REMARKS

Enclosure: New Fig. 12

FIG. 12

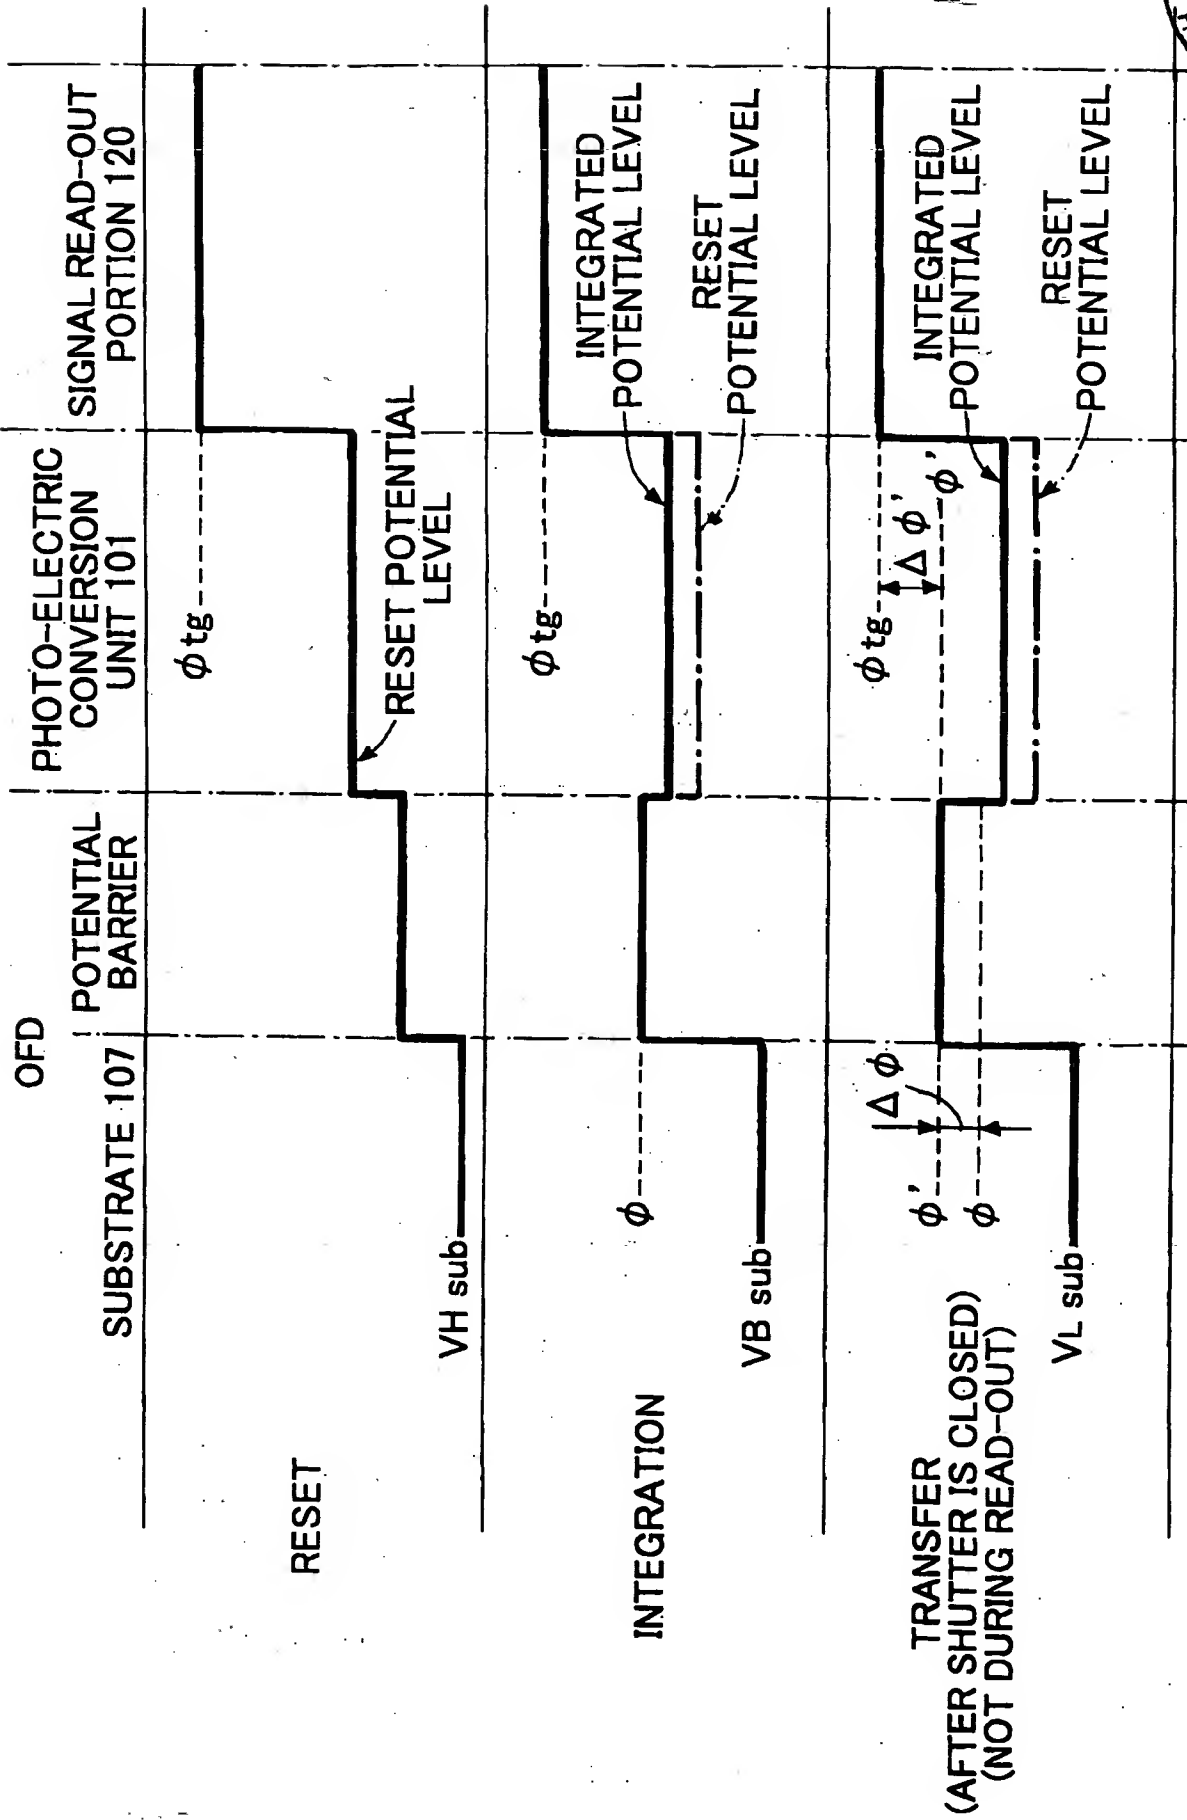
The drawings were objected to because a clear illustration of the first embodiment of the present invention is not shown. In a telephonic interview conducted on December 8, 2003, the Examiner stated that a drawing similar to the one sent by facsimile to Applicant's attorney, a copy of which was also attached to the Office Action to which this Amendment is responsive, would be sufficient to illustrate the first embodiment of the invention and allow the reinstatement of cancelled claims 3, 4, 7, 8, 11, and 12. Proposed Fig. 12 enclosed herewith is similar to the Examiner's proposed drawing. Some important differences are as follows.

First, V_{Hsub} , V_{Bsub} , and V_{Lsub} are all lower than the corresponding voltage level of the photo-electric conversion unit 101 which is supported by, for example, Fig. 2. In contrast, the Examiner's proposed drawing shows each of V_{Hsub} , V_{Bsub} , and V_{Lsub} to be at least equal to the voltage of the photo-electric conversion unit 101.

Second, ϕ_{tg} in Fig. 12 is the potential of signal read-out portion 120, not the potential of transfer gate 105/106 as shown in the Examiner's drawing.

In support of the conclusion that ϕ_{tg} is the potential of signal read-out portion 120, please note that Fig. 1 shows that " V_{Mcl} " is electrode voltage and the voltage V_{Mcl} is applied to an electrode to time t_4 . Fig. 8 shows that a part of second charge transfer electrode 106 is placed in signal read-out portion 120. Further, on page 9, lines 8-11 of the specification, it is disclosed that "When ϕ' becomes equal to or shallower than ϕ_{tg} , the charges stored in photo-electric conversion unit 101 flows through signal read-out portion 120 into vertical charge transfer unit 102."

Consequently, on page 9, lines 3-7, it is obvious that the voltage V_{Mcl} is applied to second charge transfer electrode 106, the potential ϕ_{tg} is the potential of signal read-out portion

120 and that ϕ_{tg} is caused by the voltage V_{Mcl} . Page 9, lines 3-7, has been amended to clarify this.
